TO: Mercedes-Benz Dealers, General Managers, Sales Managers, Service Managers, Parts Managers	FROM: Anthony Washington, Senior Manager, Regulations and Certifications
<b>Re: Service Campaign Notification</b> <b>Model: Sprinter</b> <b>Model Years 2019-2024</b> <b>Replace Certification Label</b>	July, 2024

<b>Campaign No. :</b>	<b>Campaign Desc. :</b>	<b>Replace Certification Label</b>
2024070001	VS3RADREI	
This is to notify you of a Service Campaign to Replace Certification Label on approximately and <b>12,796</b> MY 2019-2024 Sprinter Vans. All affected VINs will be flagged as " <b>OPEN</b> " in VMI and cannot be sold until remedied.		
<b>Background</b>		
<b>Issue</b>	Mercedes-Benz AG, the manufacturer of Mercedes-Benz Vans, has determined that on certain Sprinter and Metris vehicles, the B-pillar certification label might not contain information on the vehicle's rim size, tire size, and cold tire inflation pressure required under FMVSS 110 or, as applicable, FMVSS 120. In this case, relevant regulatory requirements might not be met. Mercedes-Benz believes this issue has no impact on vehicle safety. Mercedes-Benz intends to submit a petition to NHTSA for exemption from the notific

D00.00-A136-76

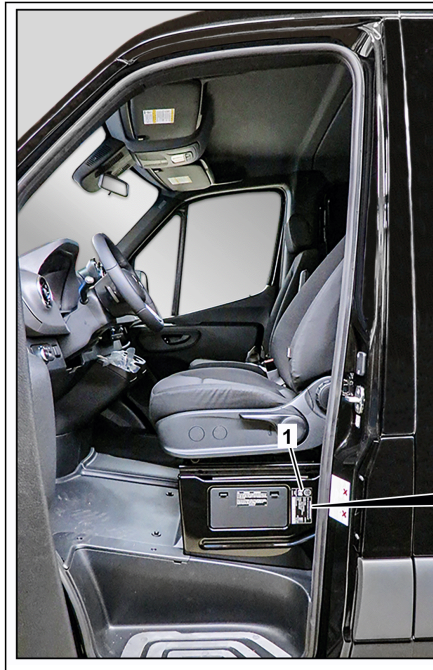
<p><b>Notice</b></p>	<p>Notes on carrying out repair work in the vehicle interior</p>		<p>AH68.00-D-0001-01KOS</p>
<p></p>	<p><b>Check</b></p>		
<p>1</p>	<p>Check whether the vehicle is affected by the measure.</p>		
<p></p>	<p><b>Remove</b></p>		
<p>2 </p>	<p>Remove vehicle identification plate (1). 000 588 00 84 00 Heat gun</p>	<p> Do not heat seat box under vehicle identification plate (1) too much. Otherwise the paint will be damaged.  To do so, remove vehicle identification plate (1) using a suitable tool.  Cleaner</p>	<p>WS54.00-P-0049B  <a href="#">BR00.45-Z-1025-04A</a></p>

<b>Attach</b>		
3	Attach the vehicle identification plate (1).	<p>⚠</p> <p>Bonding surface must be absolutely free of dust and grease. Otherwise, a sufficient degree of adhesion cannot be assured.</p> <p><b>i</b></p> <p>For "incomplete" vehicles (Code Z5U), additionally stick the new vehicle type label (1) over the old vehicle type label (1) in the supplement (3) Vehicle Data USA/CAN A-2023 (IVD User Manual) (see picture 2).</p> <p>Cleaner</p>	BR00.45-Z-1025-04A

D00.00-A137-82

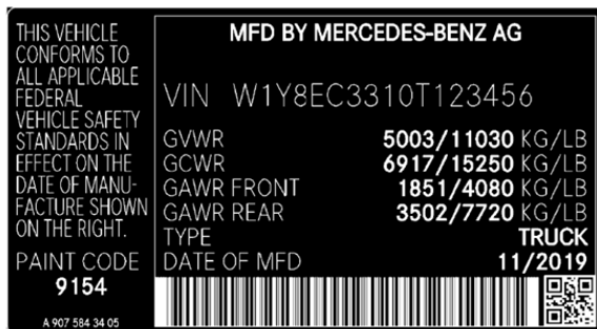
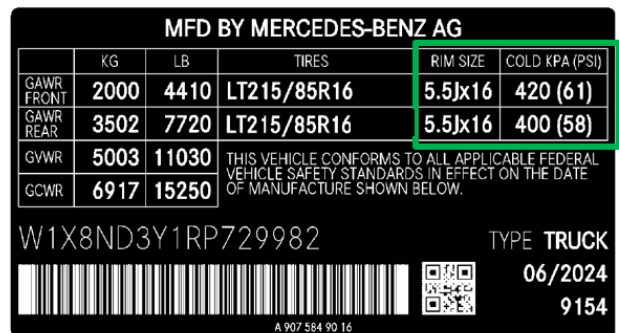
**NOK**  
 Rim size missing  
 Tire pressure missing

**OK**  
 Rim included  
 Tire pressure included
